**SOLICITATION AMENDMENT  
MODIFICATION DE L'INVITATION**

<b>Title - Sujet</b> CFB Comox FFTA Source Control Proje Projet de contrôle à la source dans l'AELI de la BFC Comox	
<b>Solicitation No. - N° de l'invitation</b> EZ113-210191/B	<b>Amendment No. - N° modif.</b> 004
<b>Client Reference No. - N° de référence du client</b>	<b>Date</b> 2021-01-28
<b>GETS Reference No. - N° de référence de SEAG</b> PW-SPWY-031-8900	
<b>File No. - N° de dossier</b> PWY-0-43021 (031)	<b>CCC No./N° CCC - FMS No./N° VME</b>
<b>Solicitation Closes - L'invitation prend fin</b> <b>at - à 02:00 PM</b> Pacific Standard Time PST <b>on - le 2021-02-23</b> Heure Normale du Pacifique HNP	
<b>F.O.B. - F.A.B.</b> <b>Plant-Usine:</b> <input type="checkbox"/> <b>Destination:</b> <input checked="" type="checkbox"/> <b>Other-Autre:</b> <input type="checkbox"/>	
<b>Address Enquiries to: - Adresser toutes questions à:</b> Leung, Janie	<b>Buyer Id - Id de l'acheteur</b> pwy031
<b>Telephone No. - N° de téléphone</b> (778) 919-3273 ( )	<b>FAX No. - N° de FAX</b> ( ) -

This Amendment 004 is raised to:

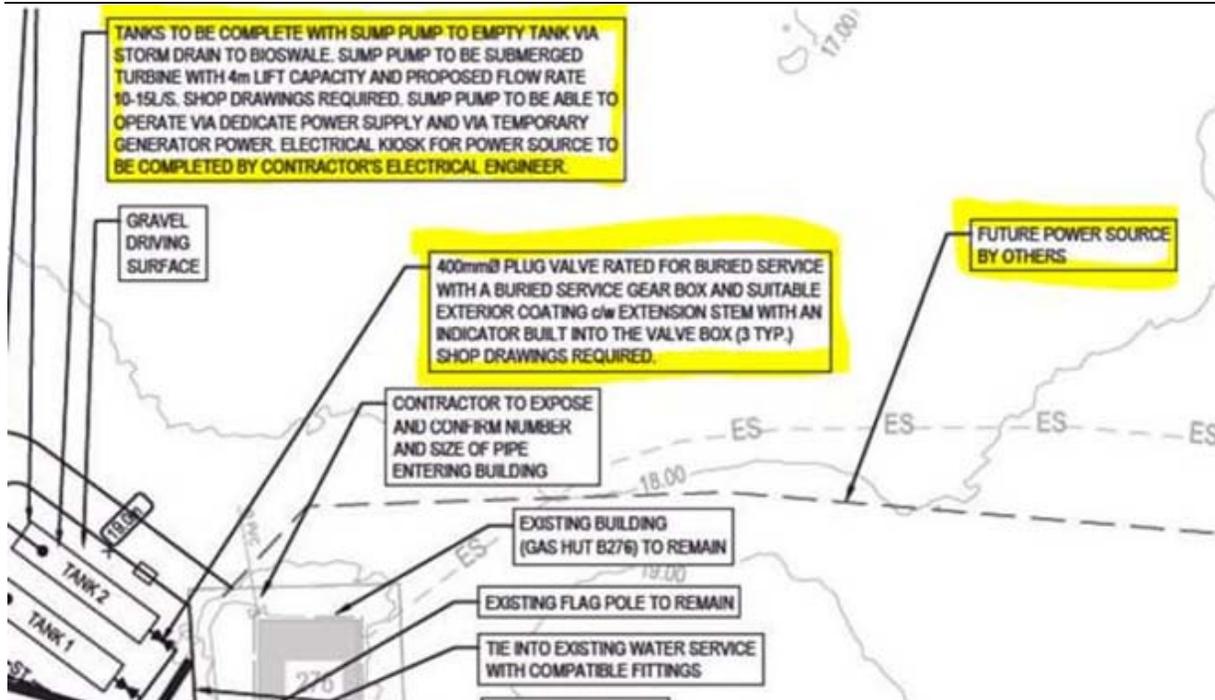
**Q5.** Who will be providing the electrical service to the pump system? It is shown as being provided by others. More info would be instructive.....

**A5.** Attention is brought to the following notes in Drawing 016, which indicate the Contractors requirements respecting power for the tank sump pump.
